# Access Compliance Report

## Public Rights-of-Way

Intersection ID: 44307	Main Street: OLIVIA_DIANE_LN	Cross Street: KIEV_DR	Location: SW
ADA ID: 8D219A2B6C05	Ramp Type: PerpDiag	Initial Pass/Fail: Fail	Overall Compliance: No
Severity Score: 8.75			
Codes/Mitigation Info/Possible Solution		Field Measurements/Component Compliance

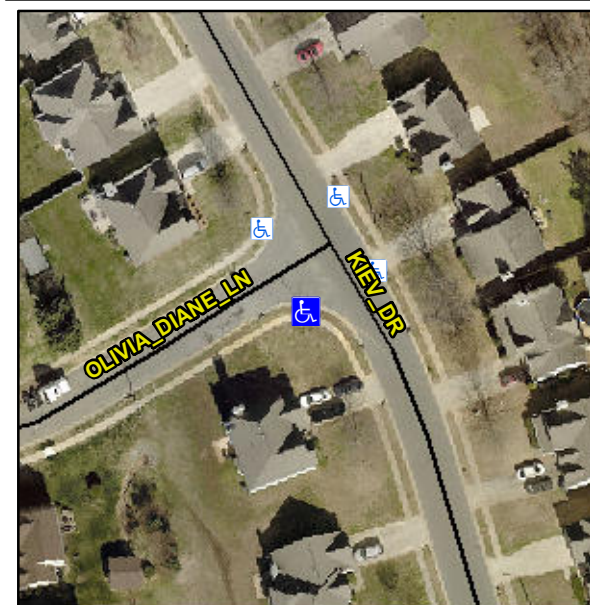
**Not Found, R304.5.1**

Compliance	Description	Data	Compliance	Description	Data
N/A	Ramp Length (in)	48.0	Yes	Ramp Slope (%)	6.0
No	Ramp Width (in)	41.0	Yes	Ramp XSlope (%)	0.6
N/A	Flare Type LT	N/A	N/A	Flare Type RT	N/A
N/A	Flare Slope LT (%)	N/A	N/A	Flare Slope RT (%)	N/A
N/A	Flare Traversable LT?	N/A	N/A	Flare Traversable RT?	N/A
N/A	Landing Length (in)	N/A	N/A	DWS Provided?	N/A
N/A	Landing Width (in)	N/A	N/A	DWS Contrast?	N/A
N/A	Landing Slope (%)	N/A	N/A	DWS Length (in)	N/A
N/A	Landing X Slope (%)	N/A	N/A	DWS Full Width?	N/A
N/A	Landing Curb? (Y/N)	N/A	N/A	DWS Offset (in)	N/A
N/A	Shared Landing?	N/A			
N/A	Gutter Ponding?	N/A	N/A	Gutter Slope (%)	N/A
N/A	Gutter Lip Ht (in)	N/A	N/A	Gutter X Slope (%)	N/A
N/A	Painted X Walk1?	No	N/A	Painted X Walk2?	No
	X Walk 1 Direction	To E		X Walk 2 Direction	To N
N/A	X Walk 1 Width (in)	N/A	N/A	X Walk 2 Width (in)	N/A
	X Walk 1 Slope (%)	0.2		X Walk 2 Slope (%)	2.0
	X Walk 1 X Slope (%)	1.5		X Walk 2 X Slope (%)	2.0

**Remove & Replace Curb Ramp With Two New Directional Ramps or Equivalent.**
